Architect's Supplemental Instructions

Architect's ASI No: 033

Webster University

Description: ASI – 033

P0101.A

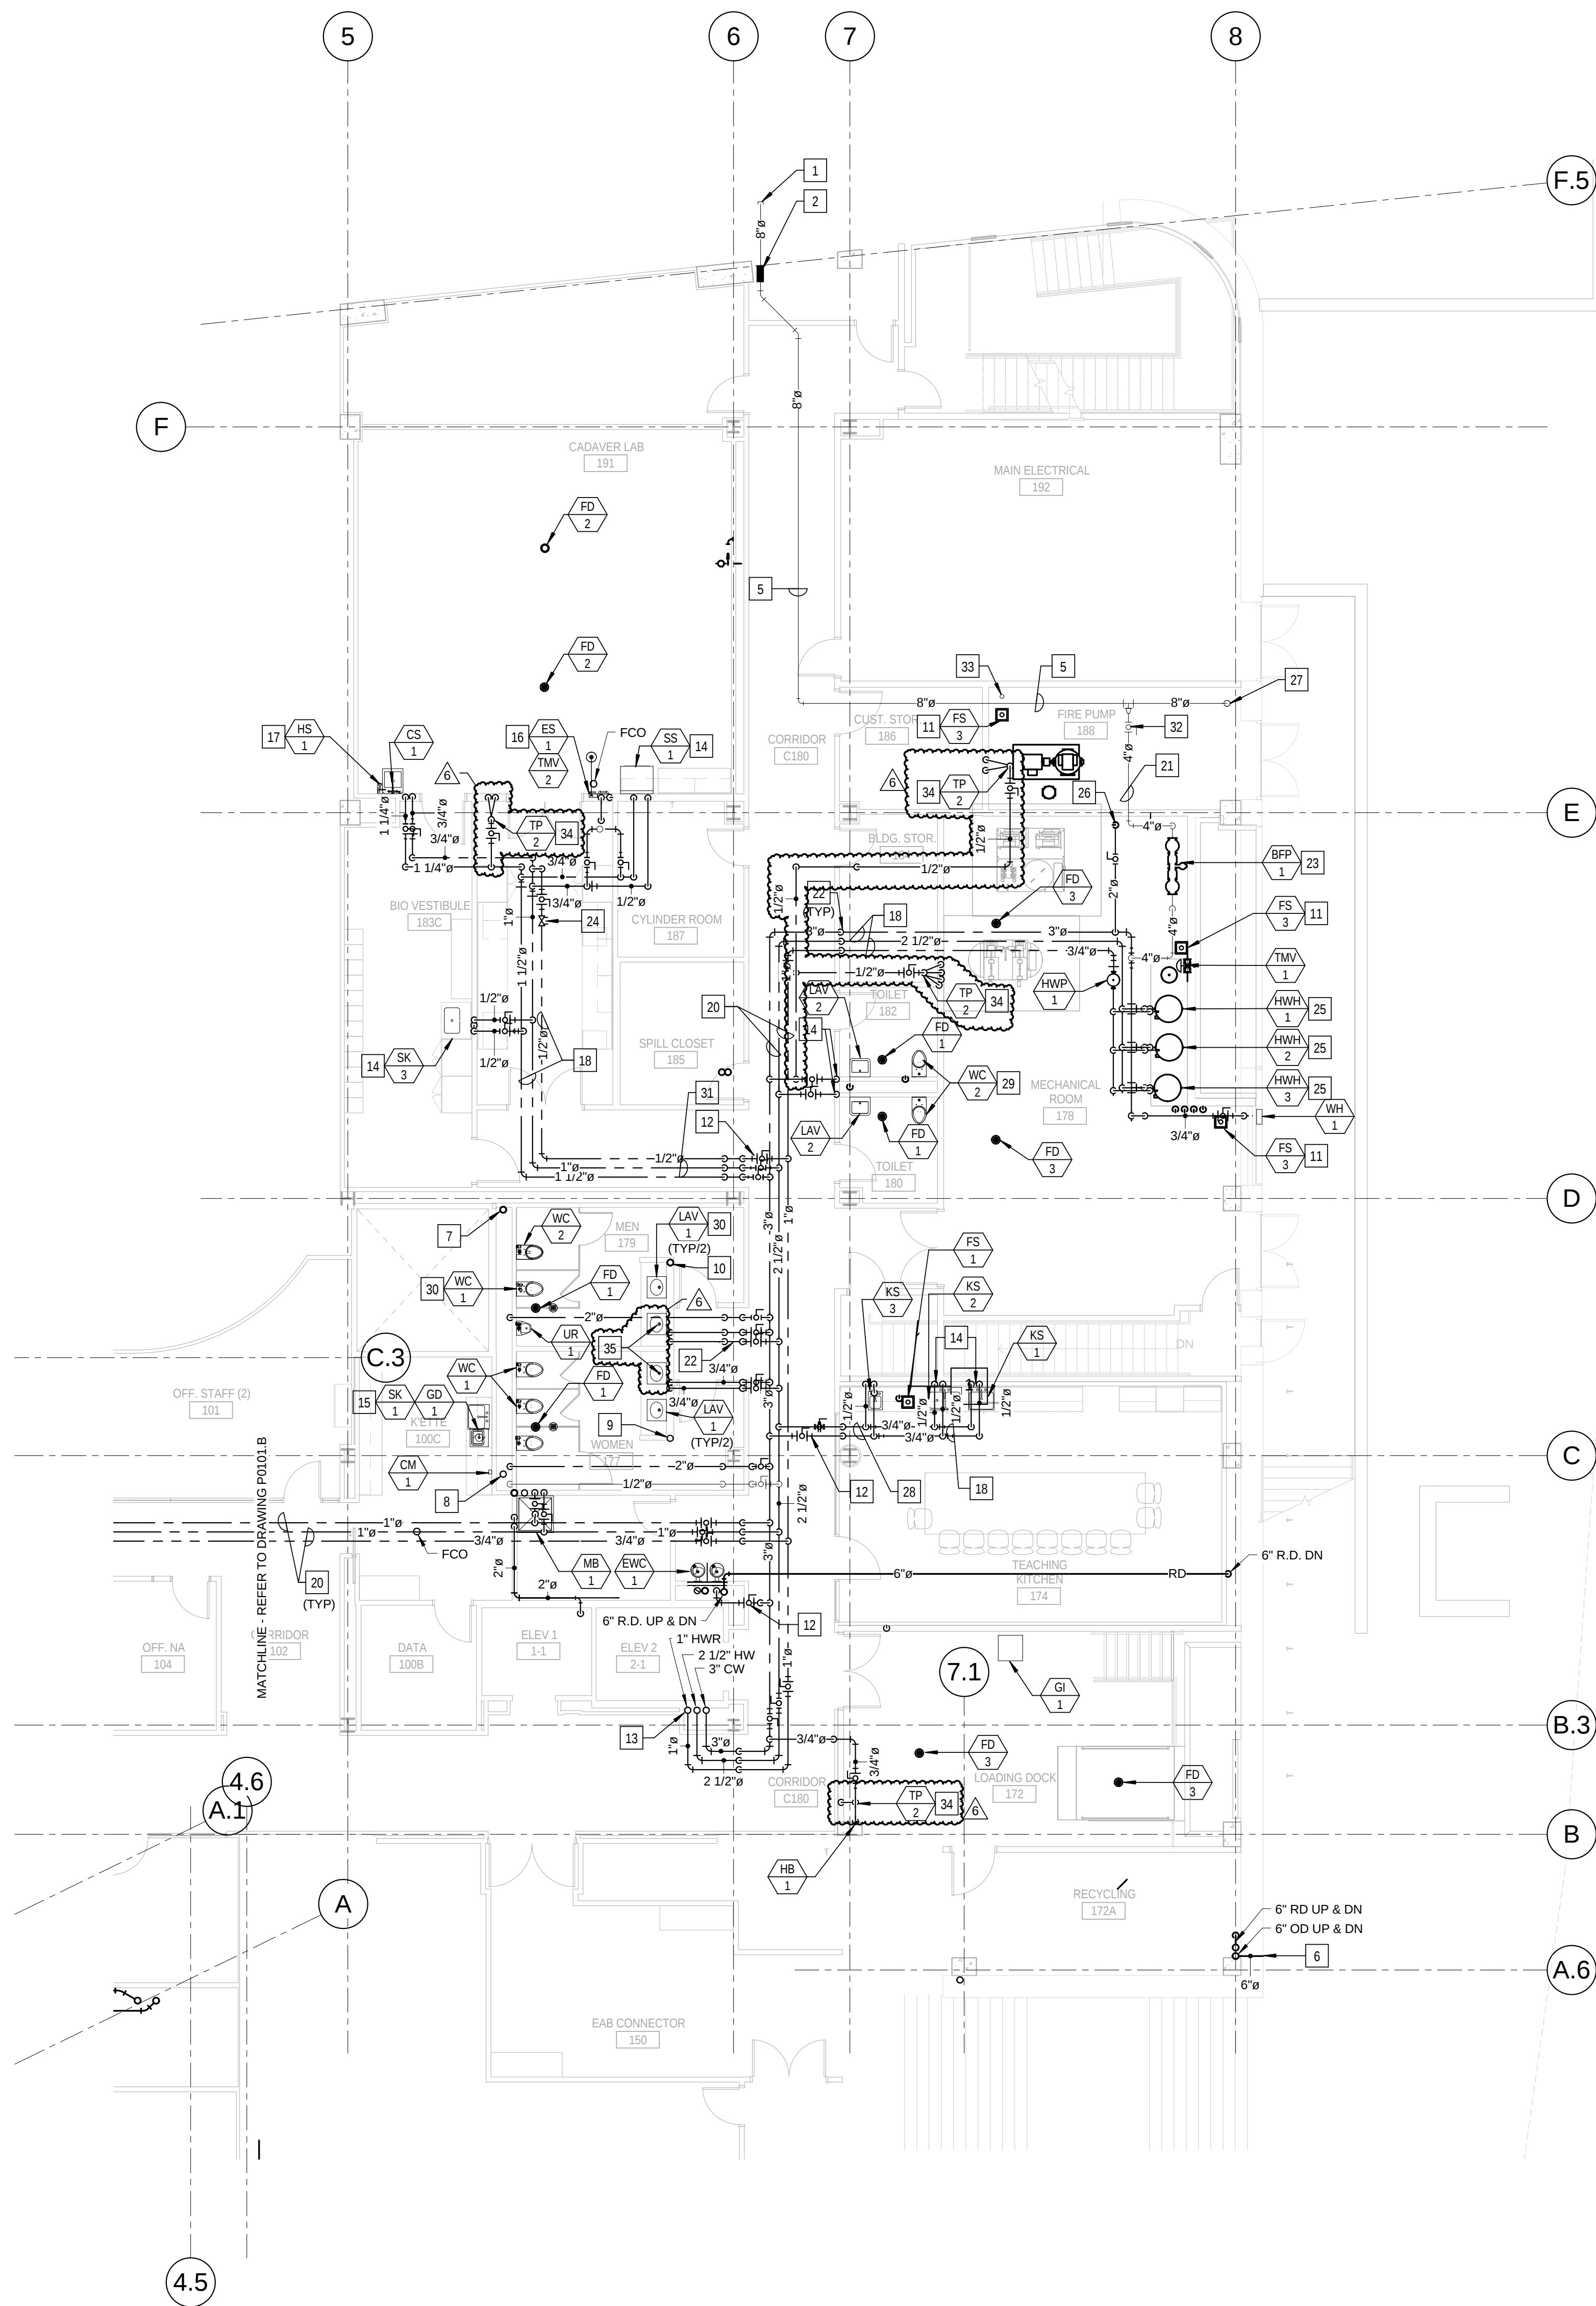
½" cold water service line down in wall has been provided for the counter top Autoclave along with a floor sink for drains. Refer to sheets P0101.A, P0102.A, P0111.A, P0112.A, P0404 and P0405 for changes.

P0102.A

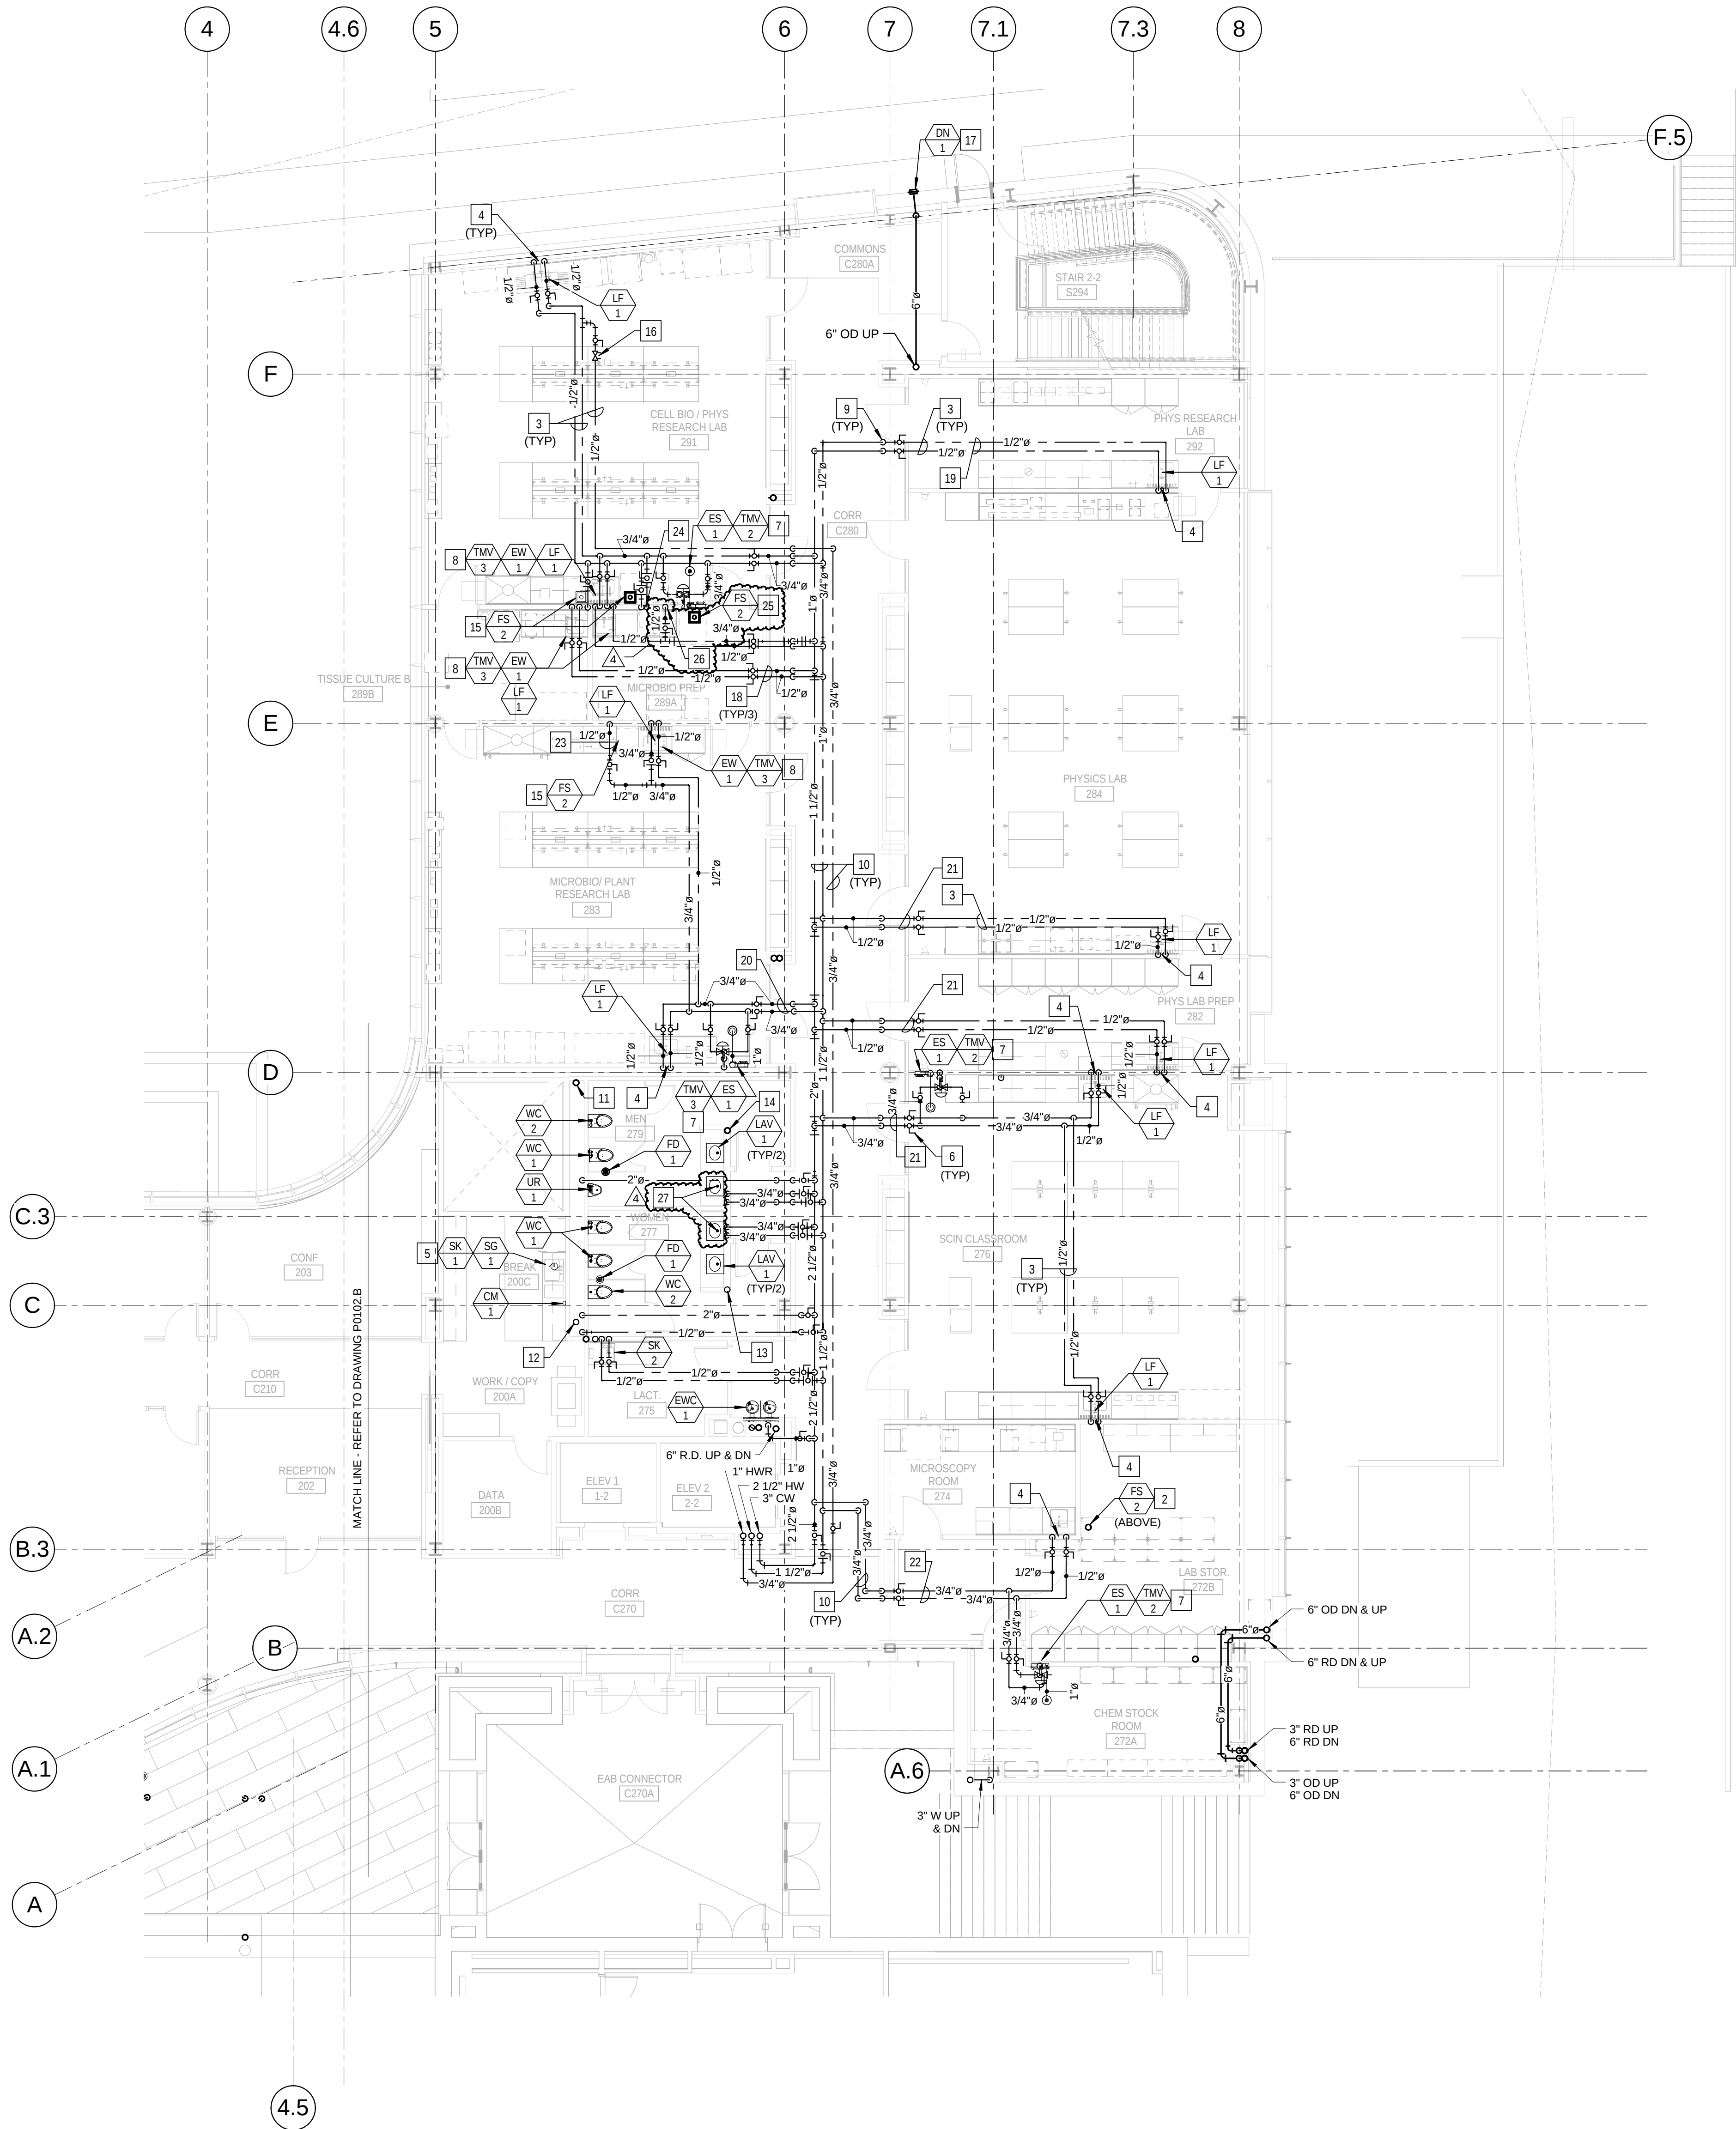
½" cold water to service line down in wall has been provided for the floor mounted Autoclave along with a floor sink for drains. Refer to sheets P0102.A, P0103.A, P0112.A, P0113.A, P0405 and P0408 for changes.

P0201.B

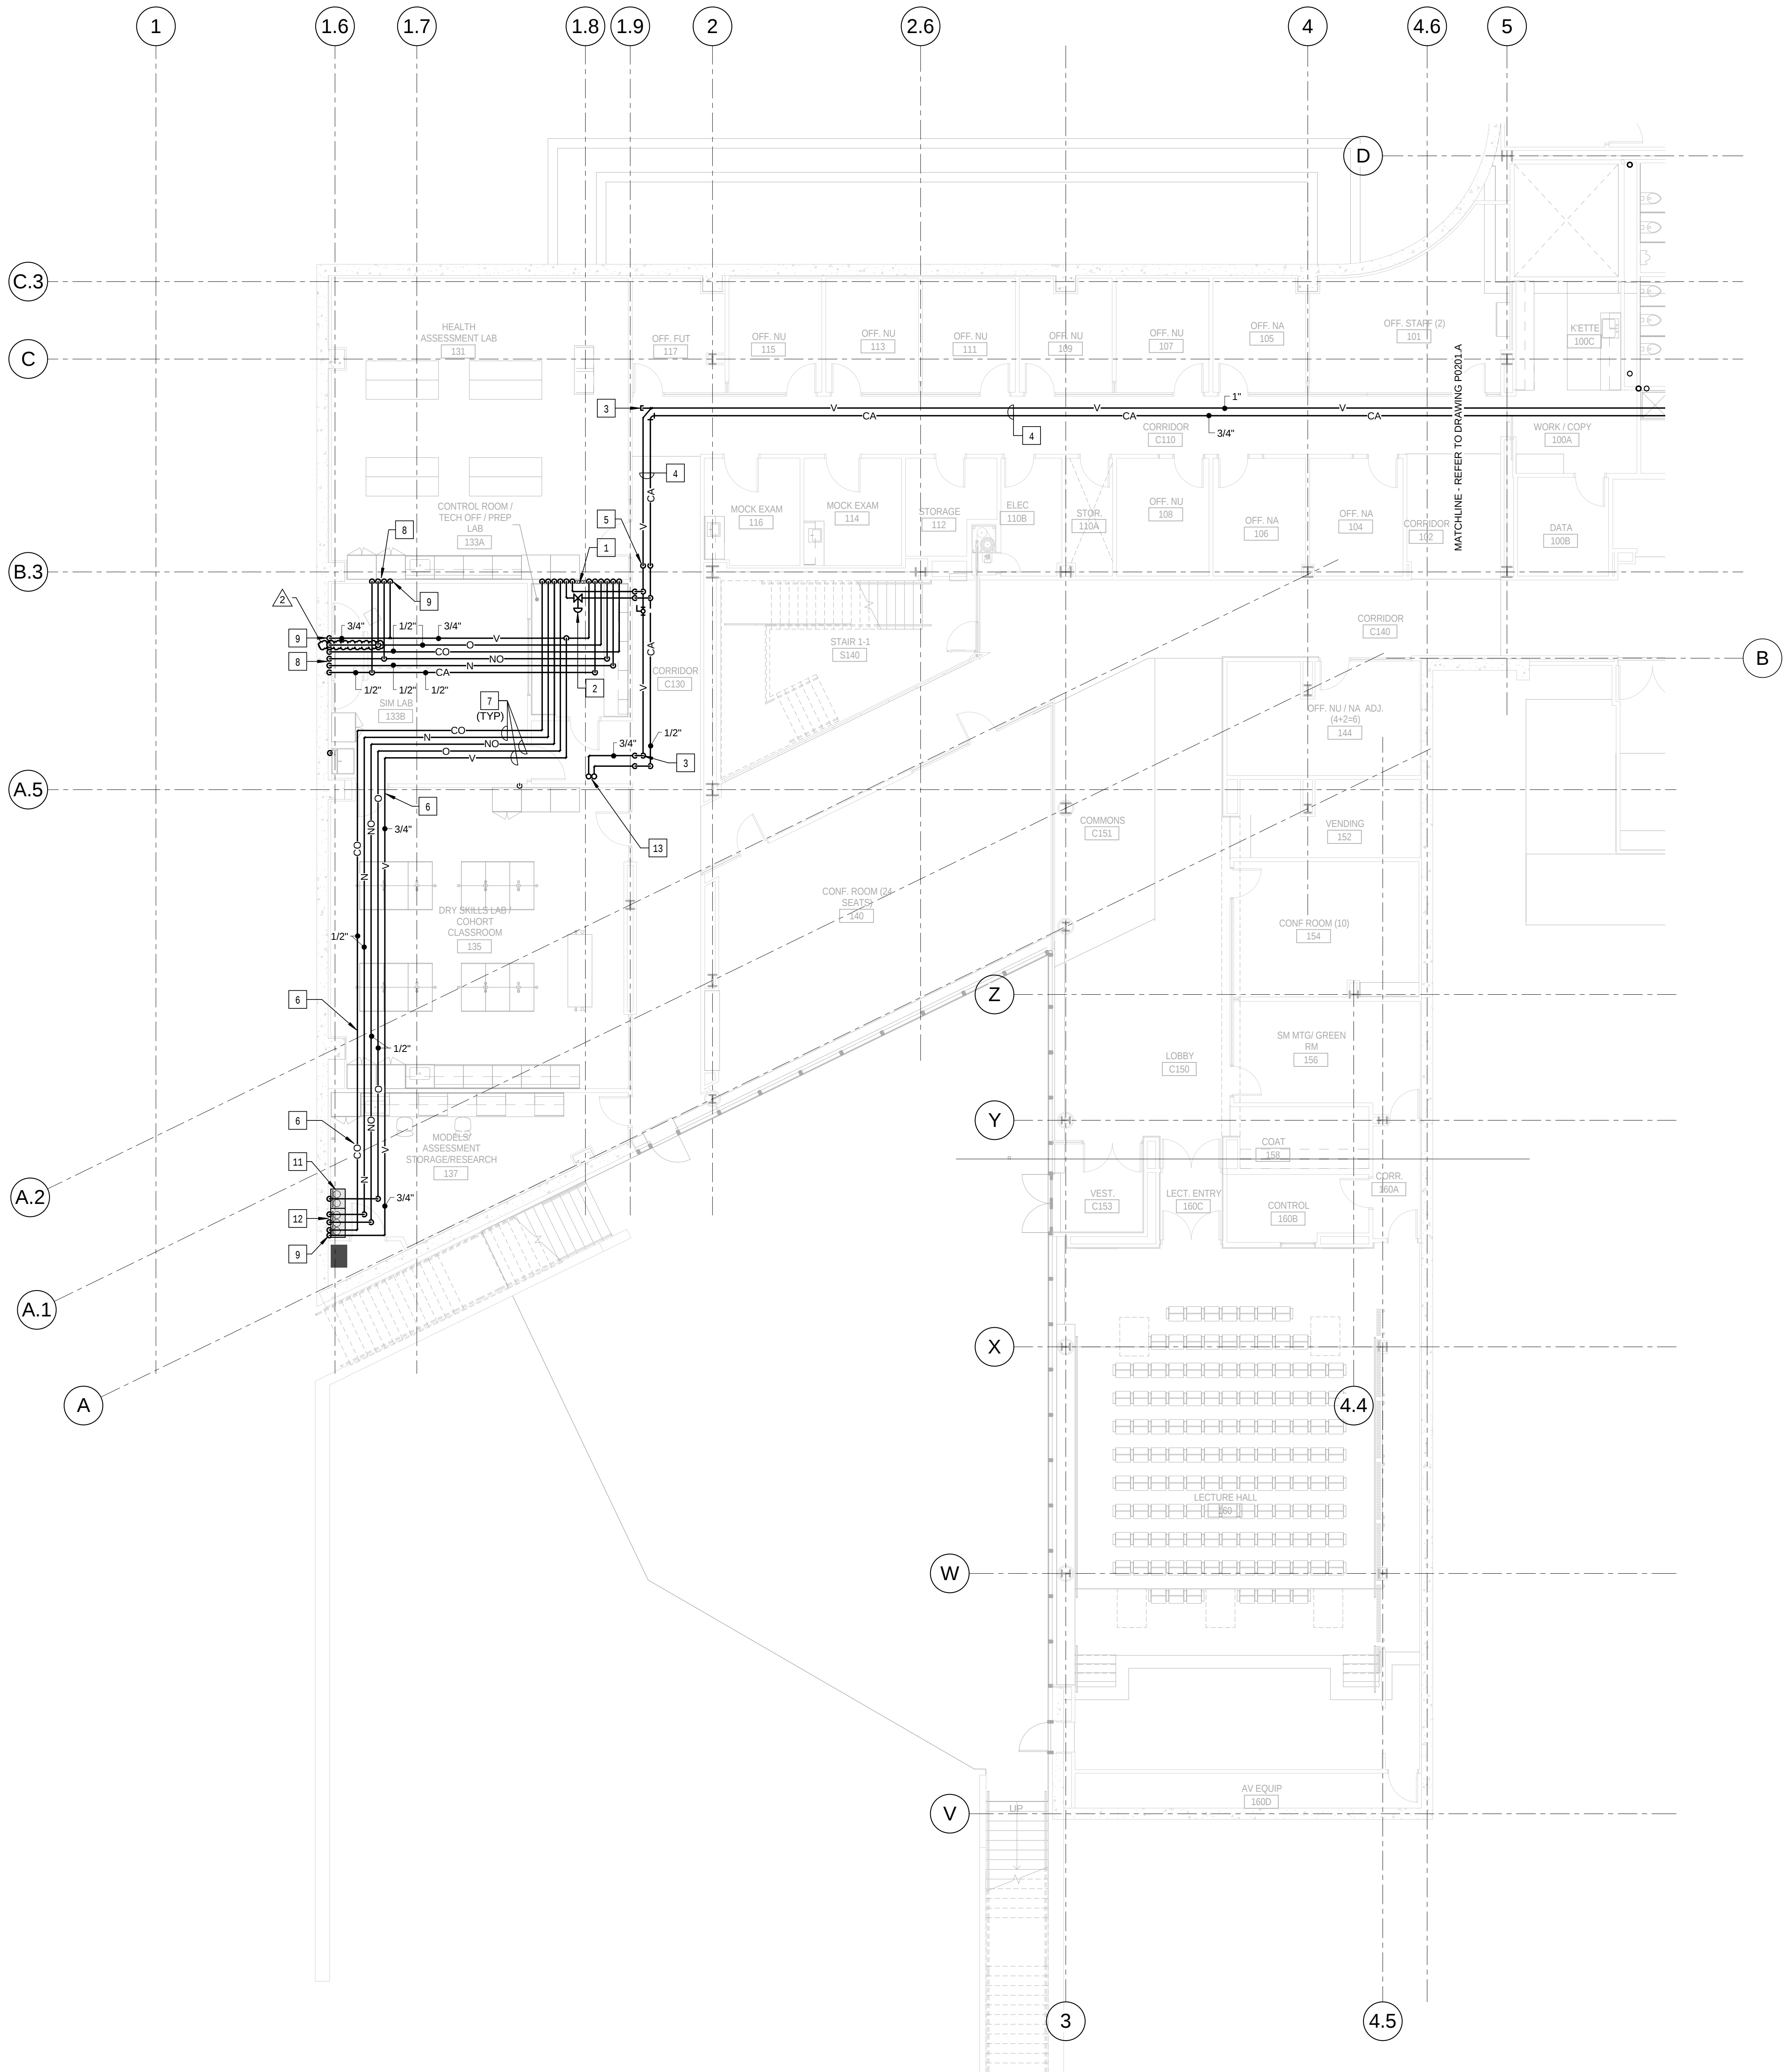
On drawing P0201.B; 1/2" oxygen service line between column line 1.6 and column line 1.7 was extended to 2 column line 1.6, drop down in wall to serve equipment on Level 1. Refer to P0201.B for changes.
